## HISTORIC AND DESIGN REVIEW COMMISSION

**HDRC CASE NO:** 2016-439  
**ADDRESS:** 201 DELAWARE  
**LEGAL DESCRIPTION:** NCB 3004 BLK 2 LOT 1  
**ZONING:** R-6 H  
**CITY COUNCIL DIST.:** 1  
**DISTRICT:** Lavaca Historic District  
**APPLICANT:** Michael Duffey  
**OWNER:** Michael Duffey  
**TYPE OF WORK:** Install driveway  
**REQUEST:**

The applicant is requesting a Certificate of Appropriateness for approval to install two 10' wide and 8' deep driveways for a rear accessory structure accessed from Staffel Street.

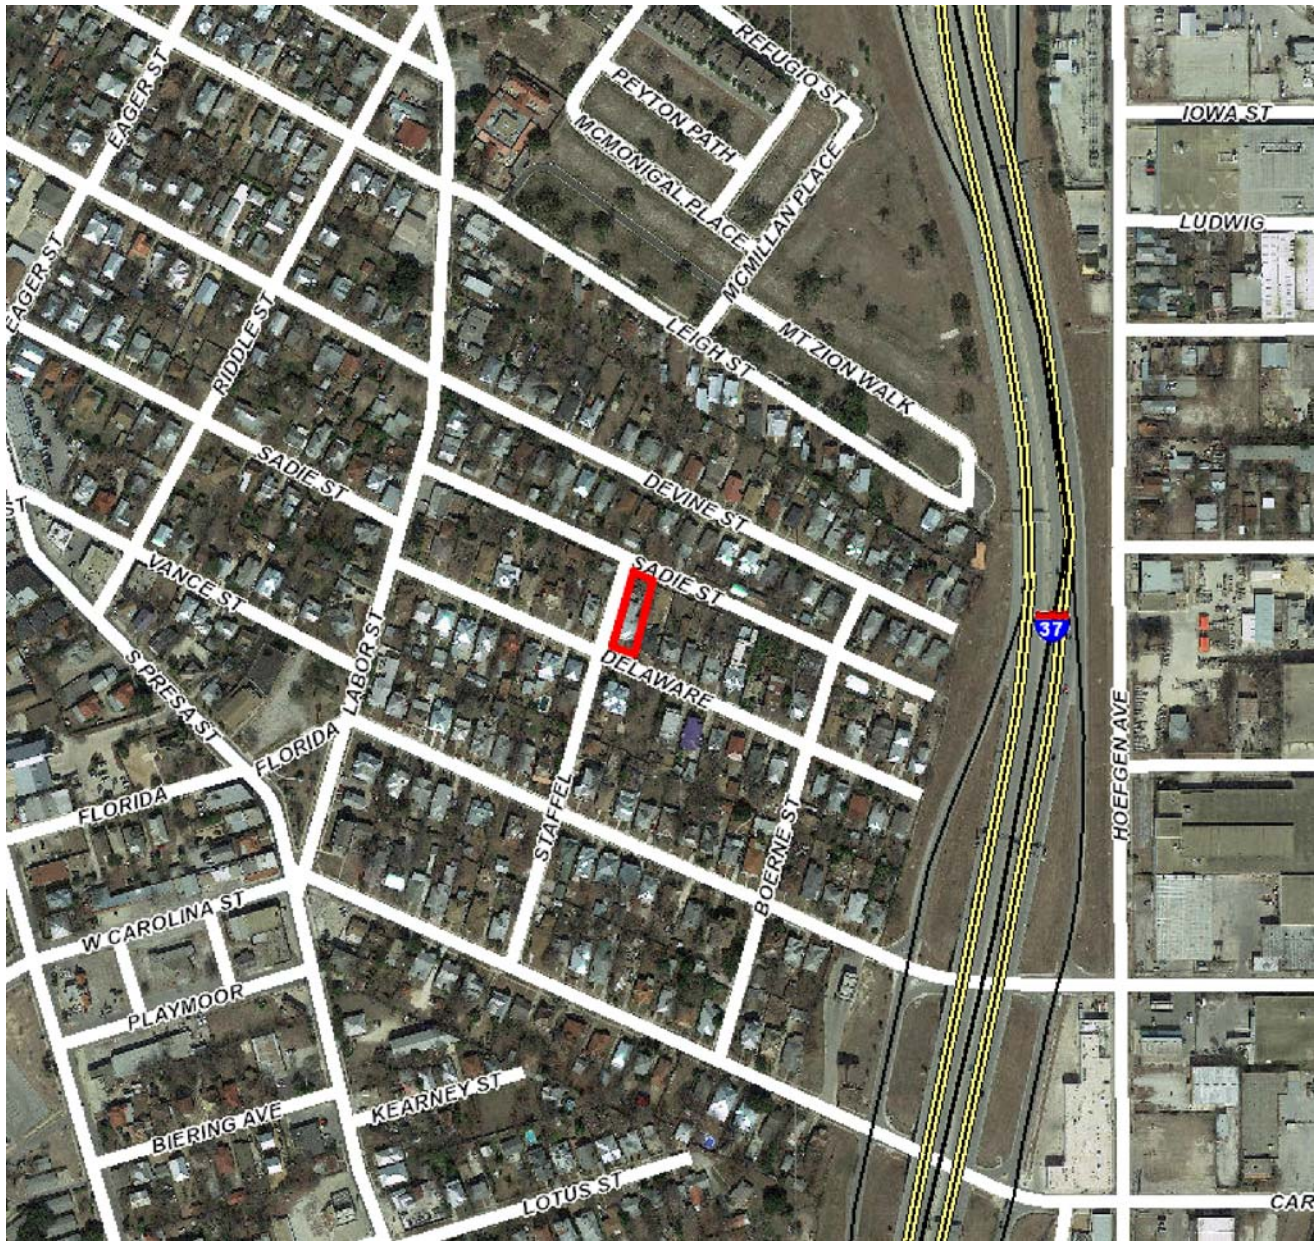
- a. The home at 201 Delaware is a one-story craftsman with a rear accessory structure that faces Staffel Street.
- b. The rear accessory structure has two garage door openings, each with a set of wooden swinging doors. There is no existing driveway. The two proposed driveways are both 10' wide, 8' deep, and made of concrete to access the rear accessory structure along Staffel Street. According to the Guidelines for Site Elements 5.B.i., historic driveway configurations should be retained and driveways are historically 10' wide. Staff finds the proposed driveway configuration appropriate for the district and consistent with the Guidelines.

Staff recommends approval based on findings a through b with the following stipulations:

1. That the driveway does not flare.
2. That each concrete driveway is no more than 10'.
